<b>PCN Number:</b>	20201210001.0	<b>PCN Date:</b>	Dec 17, 2020
<b>Title:</b>	Tape and Reel Device orientation change for TCA9509RVHR Device		
<b>Customer Contact:</b>	<a href="#">PCN Manager</a>	<b>Dept:</b>	Quality Services
<b>Change Type:</b>			
<input type="checkbox"/>	Assembly Site	<input type="checkbox"/>	Design
<input type="checkbox"/>	Assembly Process	<input type="checkbox"/>	Wafer Bump Site
<input type="checkbox"/>	Assembly Materials	<input type="checkbox"/>	Data Sheet
<input type="checkbox"/>	Mechanical Specification	<input type="checkbox"/>	Part number change
<input checked="" type="checkbox"/>	Packing/Shipping/Labeling	<input type="checkbox"/>	Test Site
		<input type="checkbox"/>	Test Process
		<input type="checkbox"/>	Wafer Bump Material
		<input type="checkbox"/>	Wafer Bump Process
		<input type="checkbox"/>	Wafer Fab Site
		<input type="checkbox"/>	Wafer Fab Materials
		<input type="checkbox"/>	Wafer Fab Process

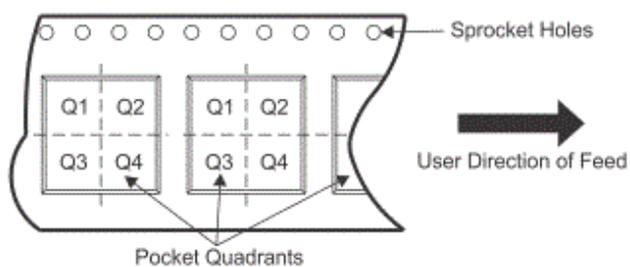
The device orientation in Tape and Reel for TCA9509RVHR assembled in JCET A/T site will be changed from Quadrant 2 to Quadrant 3 as below.

Current	Proposed
Pin 1 Orientation		
Pin 1 Quadrant	2	3
